## TECHNICAL SERVICE BULLETIN

**Models: Traditional BR Harvesters**

**SUBJECT: Conveyor Motor Failure**

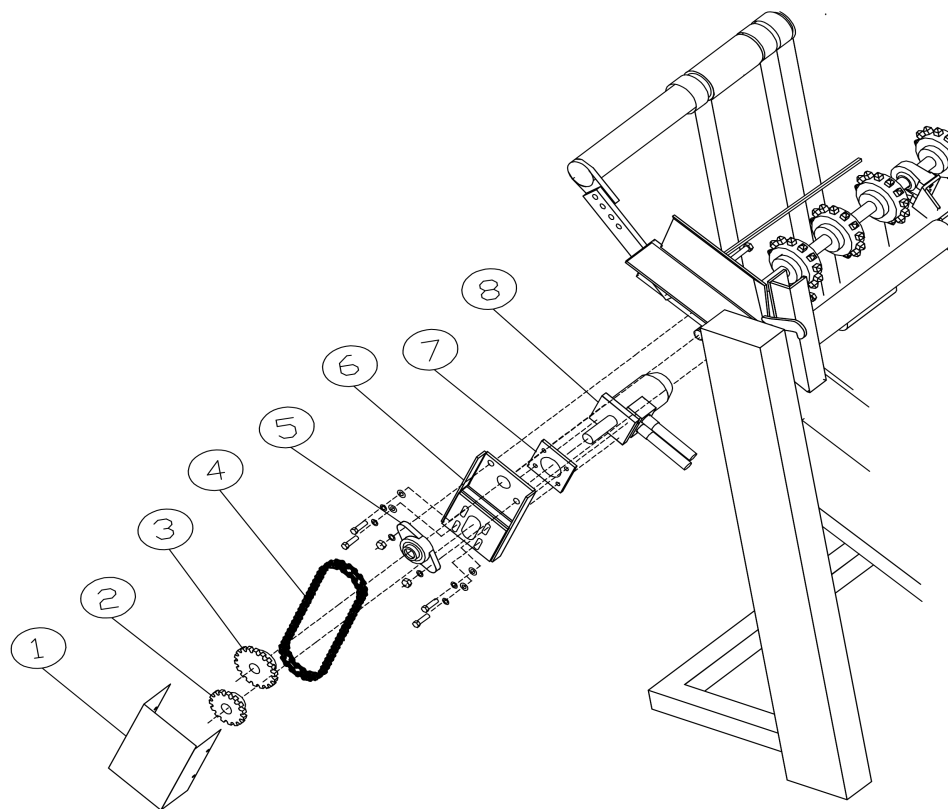
When replacing the front or rear conveyor drive motor on a BR model harvester, be certain that the motor spacer (7) is correctly installed between the motor and motor mount bracket (6). See above drawing.

If the spacer is not located between the motor and mount bracket, the shaft-end cap on the motor will crack when the motor mounting fasteners are tightened.

If the motor end cap is cracked, the motor will leak a substantial amount of hydraulic fluid. The leakage generally appears to be leaking from the motor shaft seal.

It is important to note that the motor spacer may remain on the hydraulic motor when the motor is removed from the mount bracket. **Do not discard the spacer.**

When installing the motor, tighten the motor fasteners in a crossing pattern, in several steps, to 25-30 ft.-lbs. (34-41 N.m).
